**MISCELLANEOUS DETAILS  
FOR  
DRAINAGE STRUCTURES  
STANDARD PLAN B-30.90-02**

## SUPPLEMENTAL TO STANDARD PLAN B-30.90-02

**ECCENTRIC CONE SECTION**

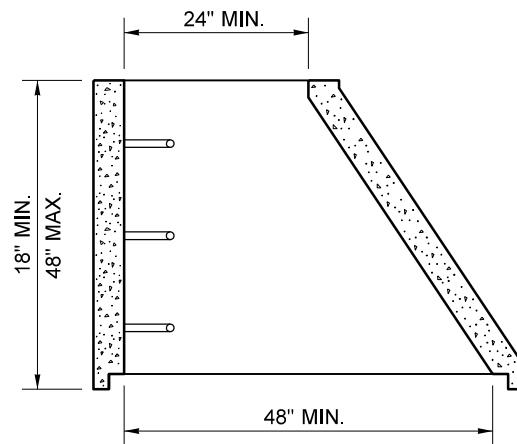
**Modify the Standard Plan as follows:**

1. No steps shall be installed within cone sections.
2. Where steps are installed, they shall be polypropylene.
